### **Meadowbank and Whale Tail IRB Report No 33**

Report No 33  
Meadowbank Independent Review Board (MBK IRB)  
Site visit August 18<sup>th</sup> to 22<sup>nd</sup>, 2025 and Montréal meeting November 18<sup>th</sup> and 19<sup>th</sup>, 2025.

**Figure 4.1 - Pit A and E, Remaining Capacity**

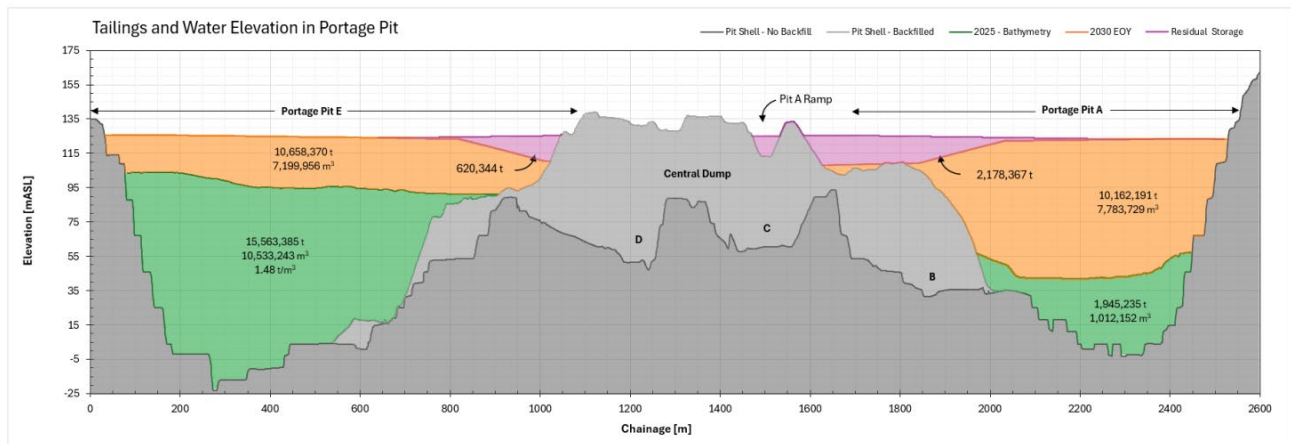
*The Board is encouraged by the advance planning of mine life scenarios with respect to tailings storage capacity, and notes that based on the current assumptions that tailing capacity in Portage Pits will be very close by 2030. It is understood that Newfields are reviewing potential long-term storage options and the board encourages being informed of the progress on this.*

Figure 5.2 Location of Pz550

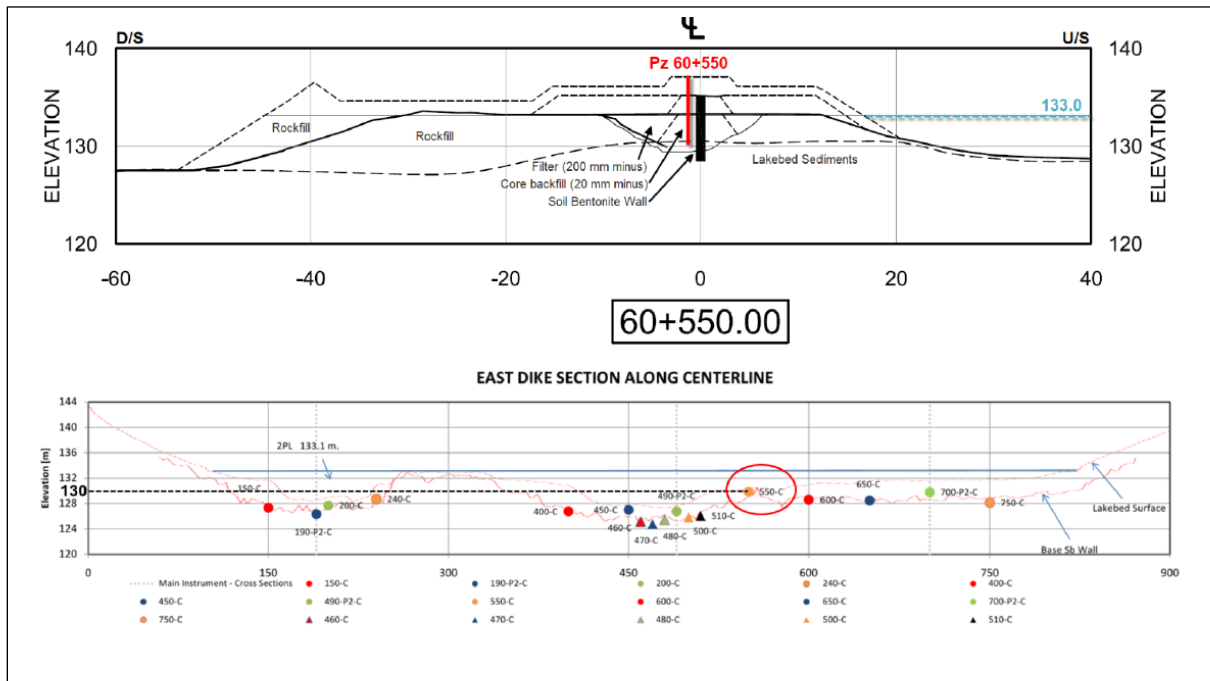
Indeed, seepage flow rates at 60+550 or slightly further to the north that report directly to the dike toe are small as can be seen on Photos 1 and 2 in Appendix B. Examination of the cross-section and longitudinal profile, shown in Figure 5.2 below, indicates that the instrument at 60+550 while situated in the core trench downstream of the cutoff, is at a topographic high and consequently any seepage would drain to neighbouring areas and to downstream. Provided no ice dams are present around the instrument, a piezometer reading indicating a dry state could be expected. Seepage may travel from 60+550 towards 60+490 where it would drain towards the pump station A. Seepage through the rock may be intercepted at the pump station A or may daylight on the pit wall further downstream.

**Figure 5.3 Instruments at 60+490**

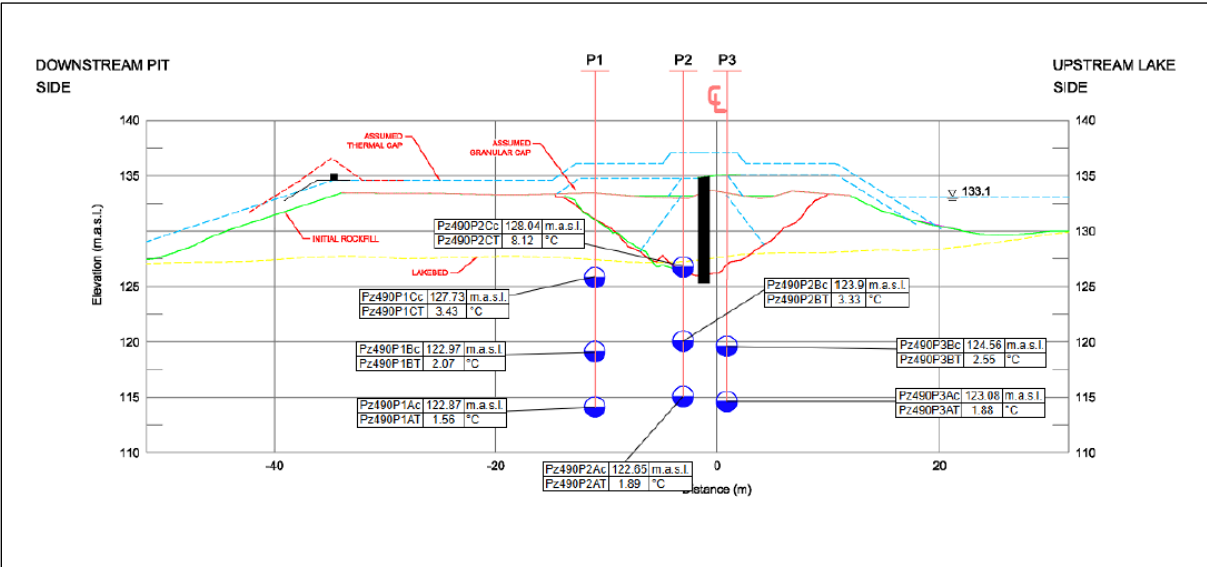
The piezometer installed at 60+490 in a similar location (Pz490P2C) in Figure 5.3 also indicates a dry state except for brief periods during freshet. The other seven instruments, installed in the bedrock show downward gradients and a general hydraulic gradient from upstream to downstream. Indeed, pressures recorded by these instruments have been steadily increasing over the past 12 years (see Figure 5.4 below), a phenomenon which is attributed to flow constrictions due to progressive freezing of the terrain downstream of the dike. However, the flow rate is enough to contribute a heat flux and prevent freezing below the dike as can be seen in the temperature readings shown in the lower half of Figure 5.4.

**Figure 5.6** Piezometric levels at select instruments of the P2 column for Stn. 31+885

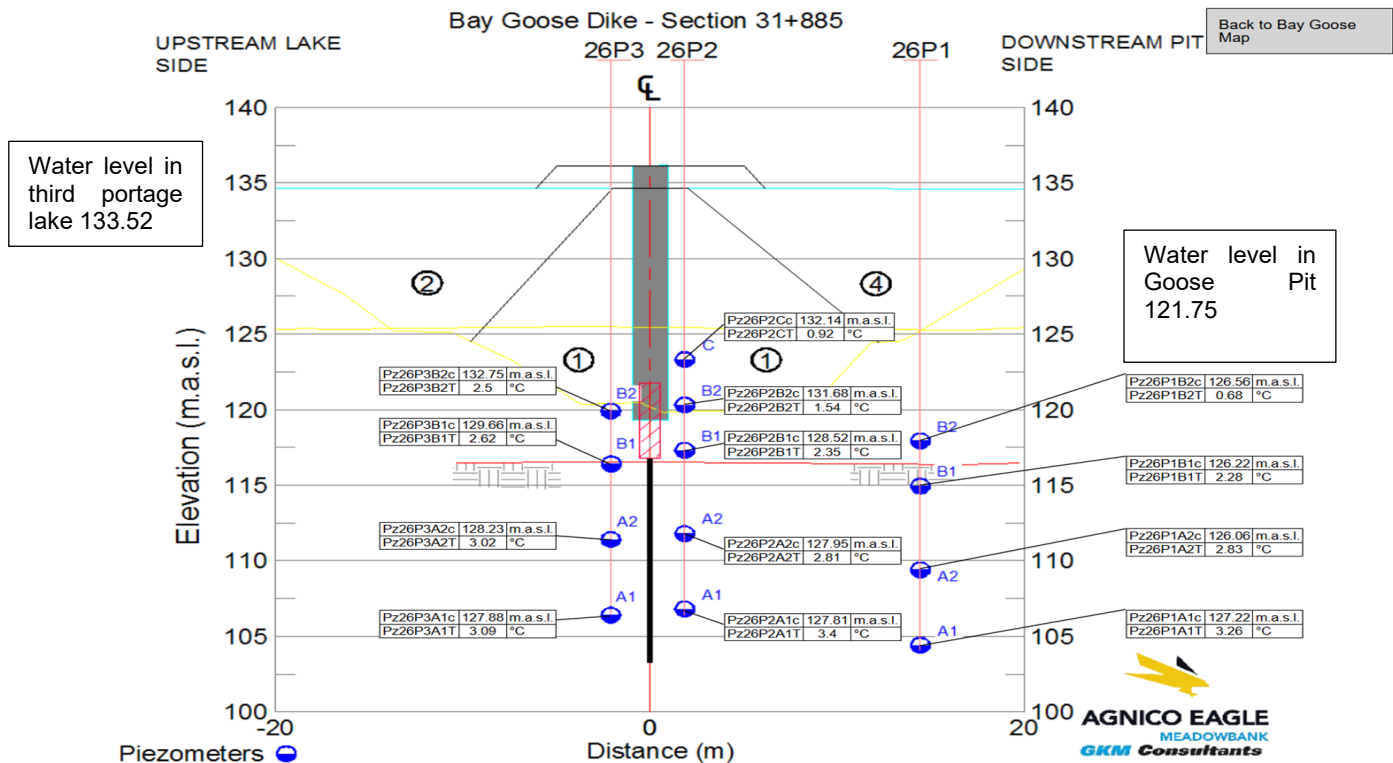
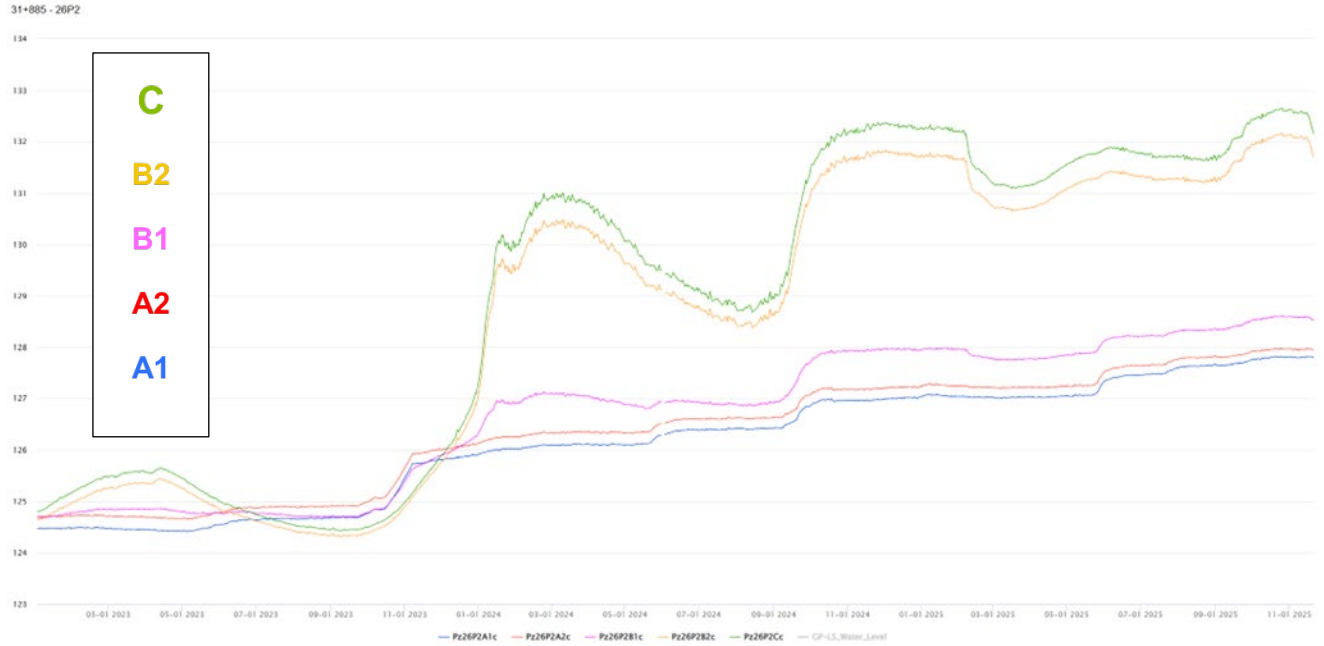
*From the Figures 5.5 and 5.6, certain observations can be made. Note first of all that these instruments are not frozen. The temperatures recorded by the thermistors incorporated in the piezometers have remained above zero since their installation. This is probably due to the fact that the series at Stn. 31+885 are located at lower elevations than the homologous installations elsewhere in Channels 1 and 2. The area constitutes a topographic low for the sector and consequently would attract seepage and infiltration from precipitation.*

*The two possible mechanisms can be identified from the graphs in Figure 5.6. The lower piezometers, P2-A1, P2-A2 and P2-B1, are believed to be influenced by backwater curves related to the raising of the water level in the Goose Pit. The pit water level rose by 0.5 m in May 2023 followed by a sharp raise from el. 114 to el. 118 in October 2023 and reached 121.75 in November 2025. The piezometers followed a similar trajectory.*

*In contrast, the cyclic changes recorded by the upper piezometers P2-B2 and P2-C, have, at least in part, a seasonal fluctuation, with values much higher than the pit water level. The increases in 2023 and 2024 occur primarily during the early winter period and are therefore unrelated to rainfall. Observations of temperature at depth, particularly in Northern regions, indicate a lag between ambient temperature lows and highs with those at depth. Peak temperatures are*
